**Proposal Title:  
Duplin County Emergency Management  
Duplin County Schools  
North Duplin Elementary School Backup Generator**

RE: RFP Questions - Duplin County Emergency Management/ Duplin County Schools  
Rose Hill-Magnolia Elementary School Backup Generator  
Kenansville Elementary School Backup Generator  
Beulaville Elementary School Backup Generator  
North Duplin Elementary School Backup Generator

**102.1 LIFT STA. ELECTRICAL RISER**  
SCALE: NONE

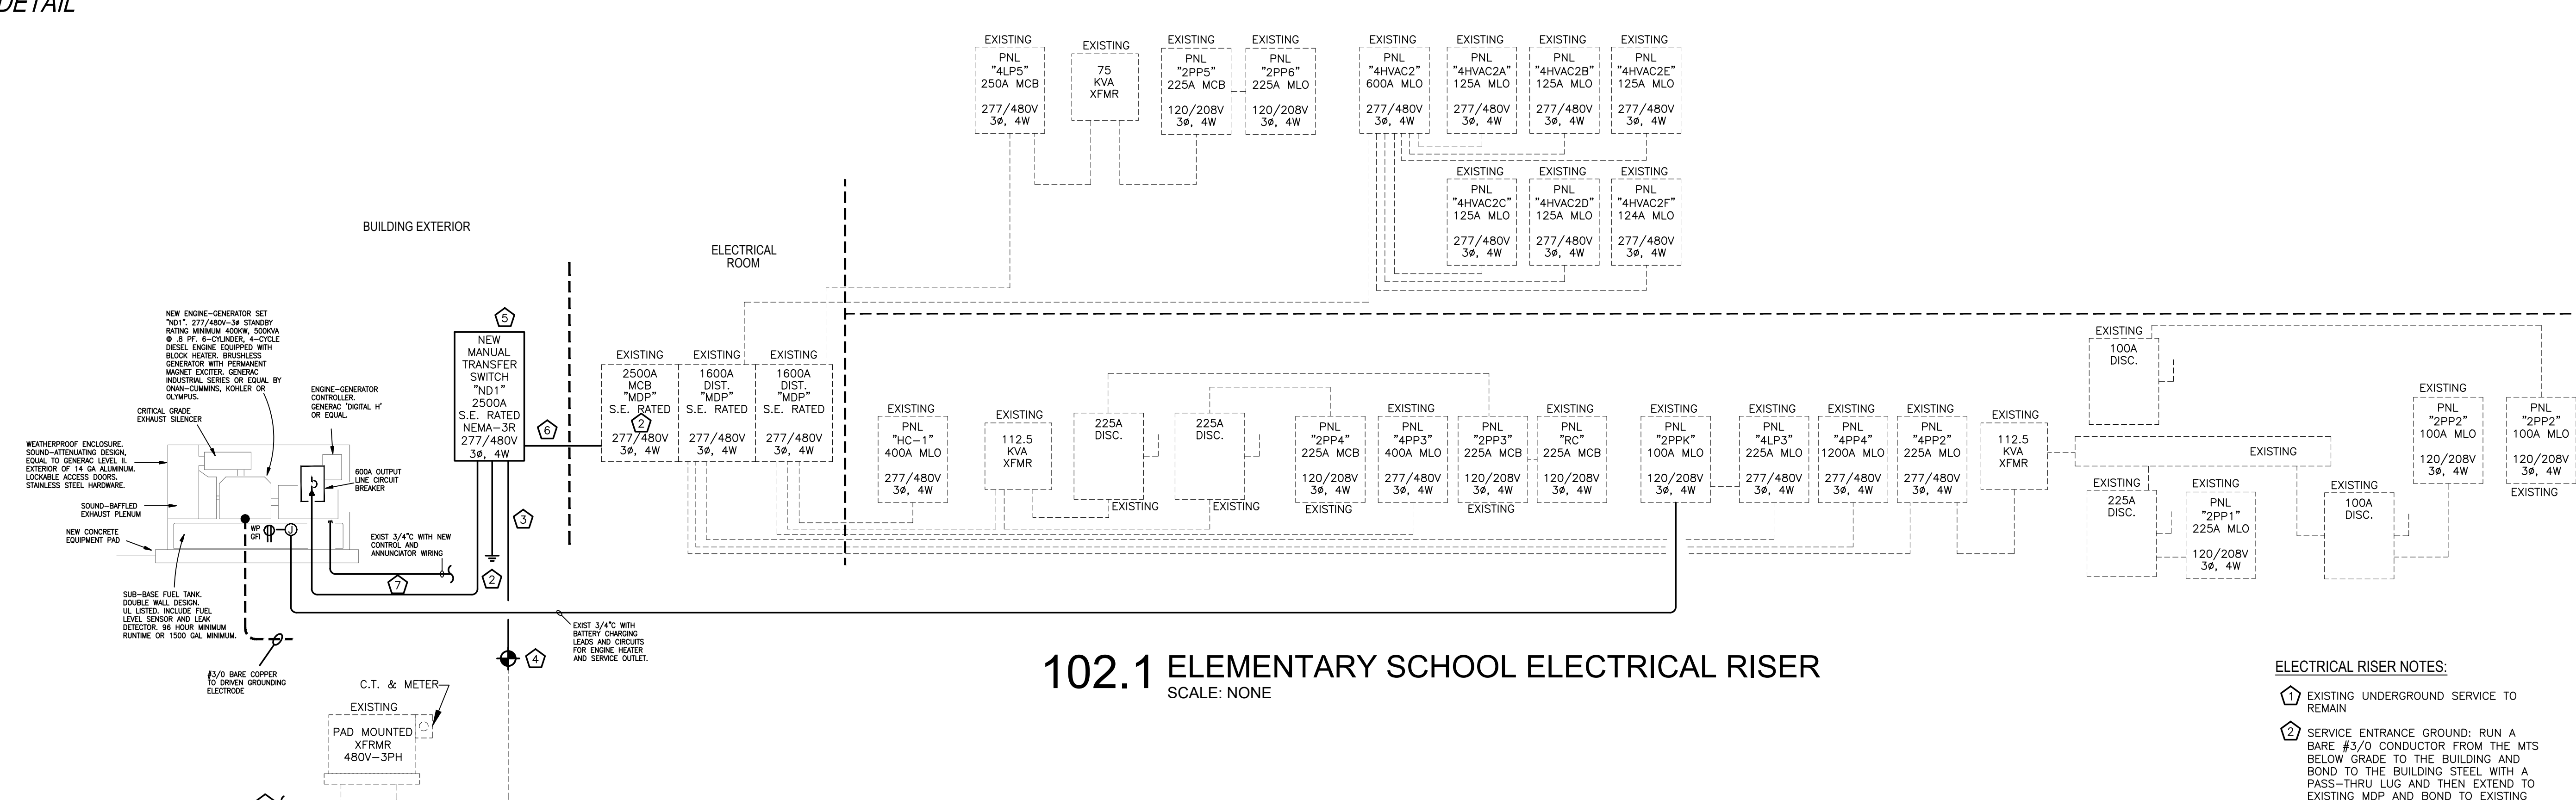
Q: When visiting the site, it was discovered that PNL ND2 did not exist on the N Duplin Lift Station. Please clarify where the 120V will be picked up from the required circuits on the generator.

A: *It was intended that ND2 was a new panel. The riser diagram on E102 specifically calls it out as new.*
